RE: Respons to Peer Review Comments
61 John Vertente Boulevard – New Bedford, MA
SE 049-0770

On behalf of the applicant, Parallel Products of New England, please find revised Site Plans and calculations enclosed with this letter. Revisions have been made in response to the comment letter prepared by the Nitsch Engineering dated October 16, 2017 in regards to their review of the Site Plans. Our responses to the comments provided in the review letter are provided on the following pages.

GRADING & UTILITY PLAN

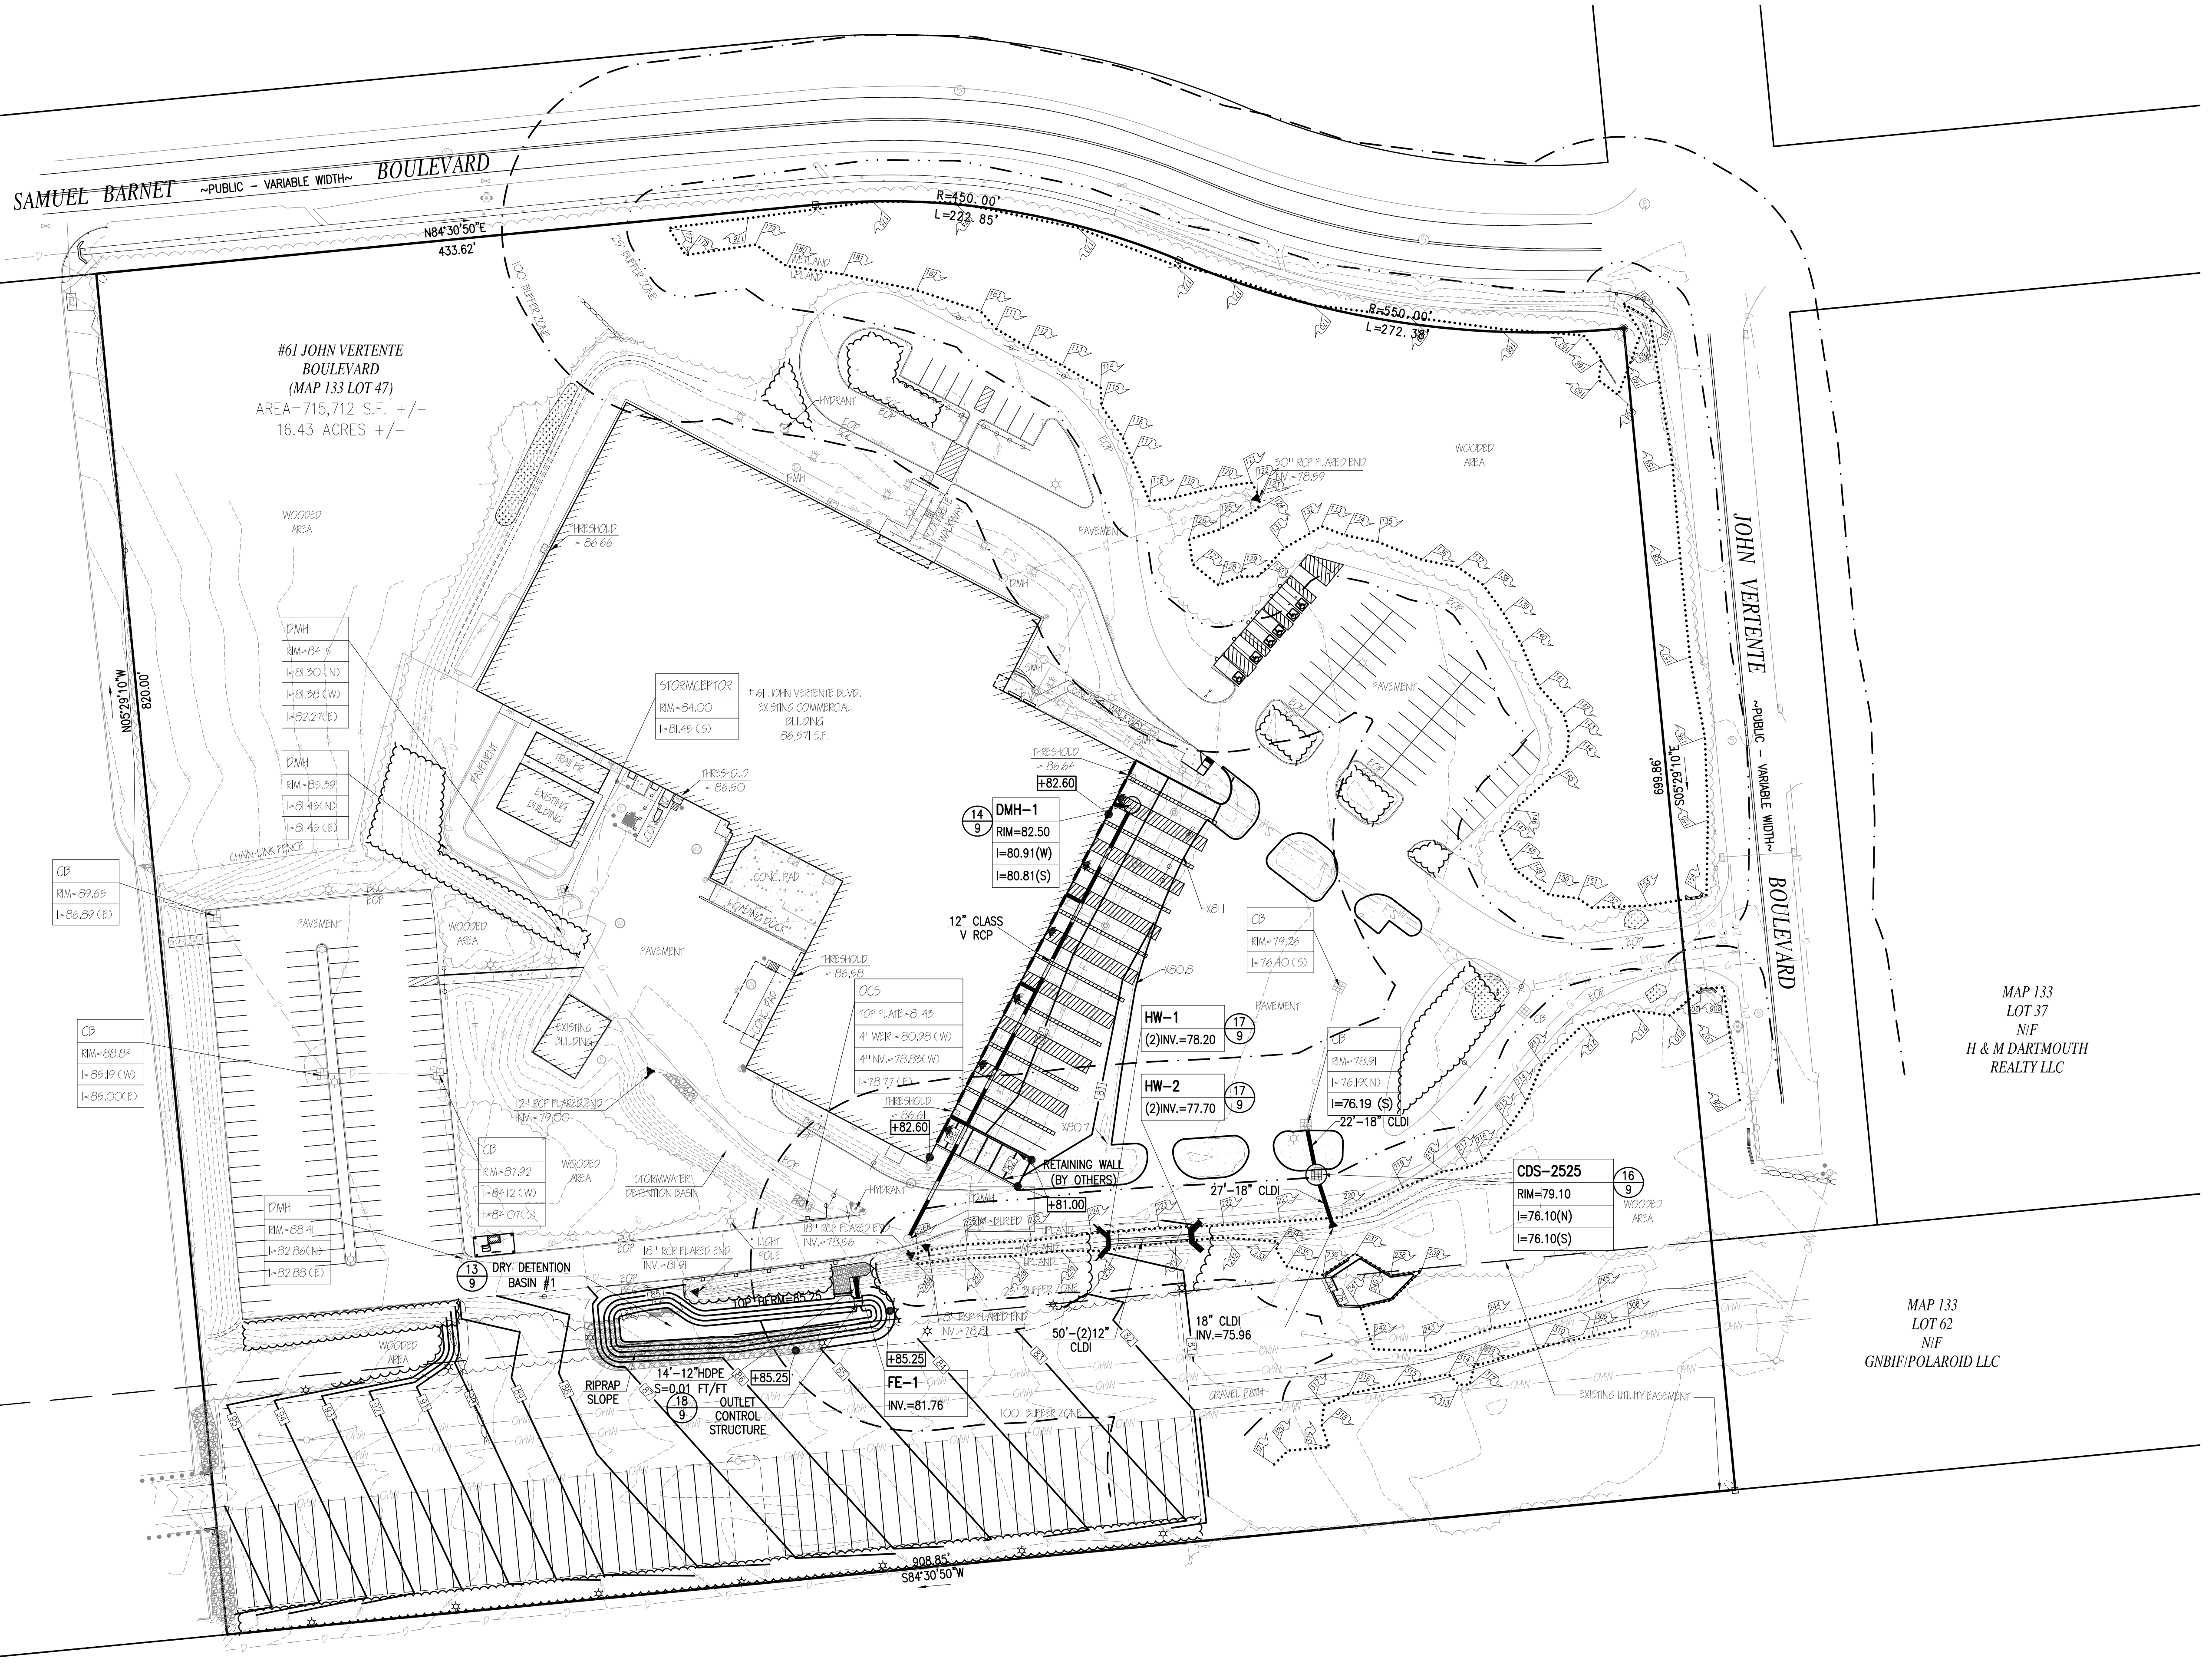
Pipe sizing calculations were provided for the existing drainage system. The existing piping system in the expanded parking area is not adequately sized to accommodate the increase in flows.

RE: Piping has been revised to accommodate the existing and proposed flows. Two existing 12" concrete pipes are proposed to be replaced with 18" ductile iron pipe. This will require temporary disturbance at the piping system discharge located in the BVW, to replace the existing pipe.

DETAIL SHEET
SHEET 9 OF 9

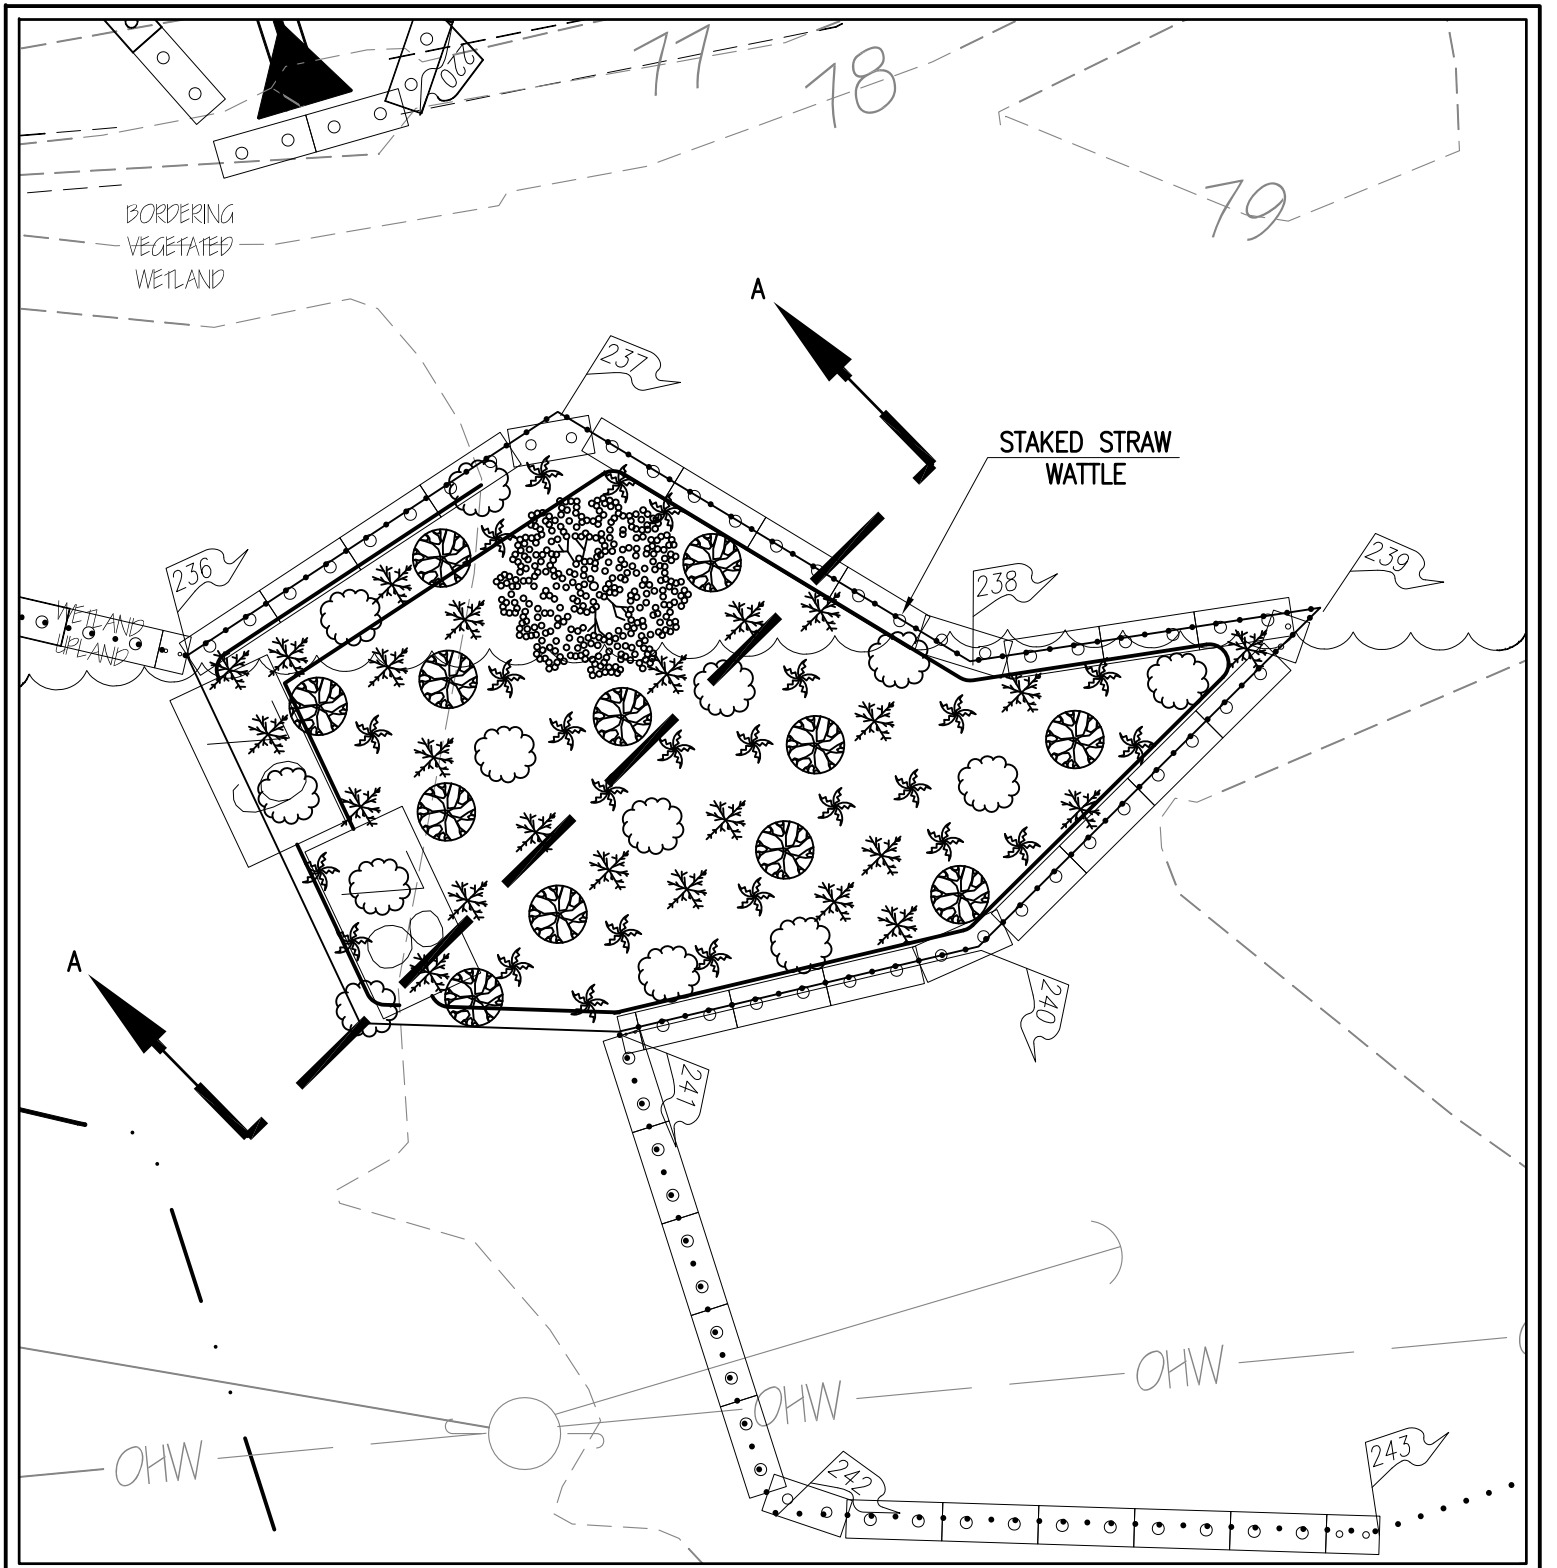
A test hole was performed in the vicinity of the proposed stormwater basin. The test hole shows seasonal high groundwater at elevation 81.8 and the proposed bottom of the stormwater basin is at elevation 82. Since the stormwater basin has not been designed for infiltration, this level of separation from groundwater is accepted. We recommend that the bottom of the basin be lined to protect any pollutants from leaching into the groundwater table.

RE: A basin liner to be installed at the bottom of the proposed basin has been added to the construction detail on Sheet 9.
